American Telecommunications Certification Body Inc.  
6731 Whittier Ave, McLean, VA 22101

RE: Two Technologies Inc.

FCC ID: RYJJETTXL

After a review of the submitted information, I have a few comments on the above referenced Application.

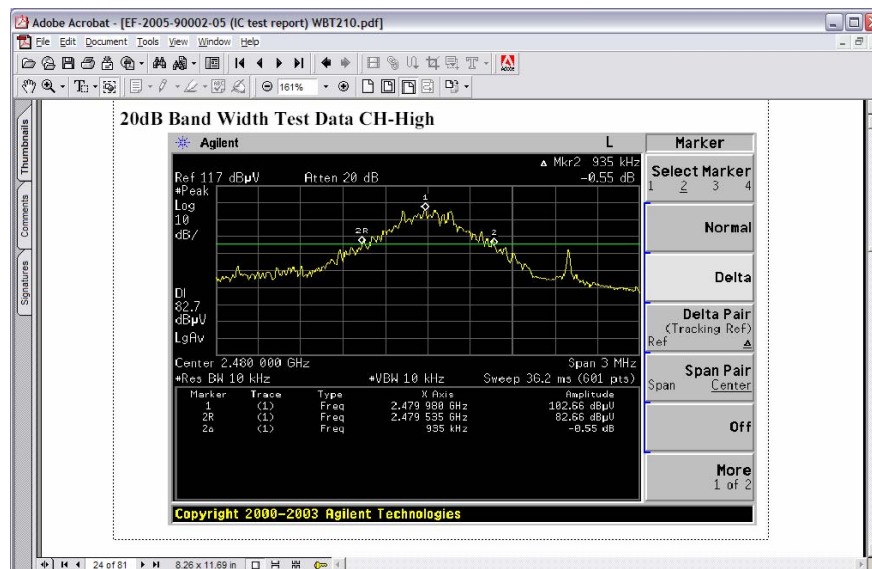
- 6) The 20 dB occupied bandwidth for a Bluetooth is typically just under 1 MHz. Usually when a narrow occupied bandwidth is shown, it is found that the occupied bandwidth/bandedge tests may not have been activated with proper modulation. Please review/correct as this will affect these results (bandedge, occupied bandwidth, spectral density). Below is a typical 20 dB test result.
